Van: @Nedmag.nl>
Verzonden: woensdag 8 juni 2022 17:14
Aan: @sodm.nl>
CC: @we-p.nl>; @Nedmag.nl>; @we-p.nl>;
@Nedmag.nl>; @we-p.nl>; @Nedmag.nl>; @we-p.nl>;
@we-p.nl>; @we-p.nl>; SodM Boren <Boren@SodM.nl>; SodM Info <info@SodM.nl>;
@Nedmag.nl>
Onderwerp: Nedmag - VE-5 - MoC

1. Information			
Temporary Change	<input type="checkbox"/>	Minor Change	<input type="checkbox"/>
Medium Change	<input checked="" type="checkbox"/>	Major Change	<input type="checkbox"/>
Operator informed	Yes <input checked="" type="checkbox"/> No <input type="checkbox"/>	SodM informed	Yes <input type="checkbox"/> No <input checked="" type="checkbox"/>
Contact name	()	Contact name	info@sodm.nl
Name	()	Datum:	03-June-2022
Function:	()		
Project Name:	Nedmag VE-5/6 Drilling		
Location:	Veendam		
Proposed Adjustment:	Pressure test on 16" casing reduced from 200 bar to 125 bar

2. Justification of MoC

INTRODUCTION

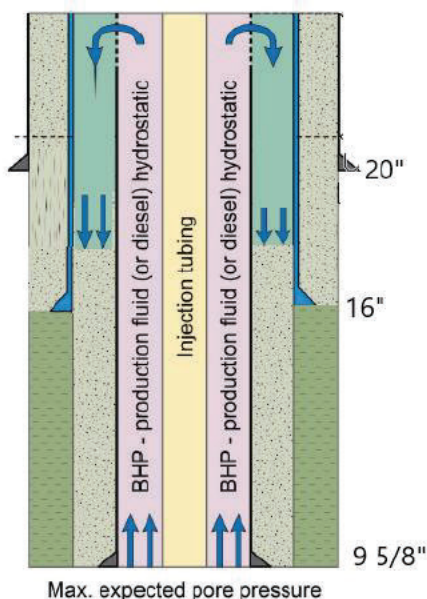
The original plan for VE-5 was to perform a pressure test to 200 bar on the 16" casing. The casing failed the pressure test after cement hardened. A successful pressure test with cup type tester in first joint below hanger, proves the leak to be below surface. To rule out a leaking shoetrack, a cement plug was placed on the stab-in collar with TOC at 1230m MD. After cement hardened the pressure test was repeated, but still did not fulfil the requirements. A second test to a lower value of 128 bar was performed and this time the pressure test was good.

Burst loads as a result of 9-5/8" leaking at the wellhead; blanket fluid column at full lithostatic pressure exerted on the 16" casing (250 bar) against TOC at surface (WORST CASE LOAD). 16" casing is connection limited to 223 bar (including 1.1 design factor). Following mitigations to be implemented to minimize risk: multiple seals on hanger 9-5/8", pressure alarm on 16". The chance on a lithostatic pressure on blanket fluid column is small, limited use of hydrocarbon blanket. After cementation of 9-5/8" the 16" will have an enclosed annulus, taking the well in production (heating up) the pressure in the 16" will rise, requiring bleed-off => pressure alarm with action. Potential a nitrogen cushion can be installed.

*Maximum expected pore pressure 12 ¼" hole section = 1.39 s.g. – Gas gradient 0.23 s.g. * 1714m TVD hole*0,0981 = 195 bar. Limited to fracture at shoe with 120 bar (formation strength at 16" shoe of 1,70 s.g. EMW)*

Update: shoe at 860m, with 1.7 frac EMW, MEWHP = 124 bar

With the 128 bar pressure test on the 16" casing the MEWHP criteria is fulfilled and drilling of the well can continue as per program.

Multiple seals on hanger 9-5/8"

Pressure monitoring on 16" with alarm at 128 bar

When taking the well in production (heating up) the pressure in the 16" might rise, requiring bleed-off

Drilling can continue. During production phase of the well the measures that were already planned will be followed.
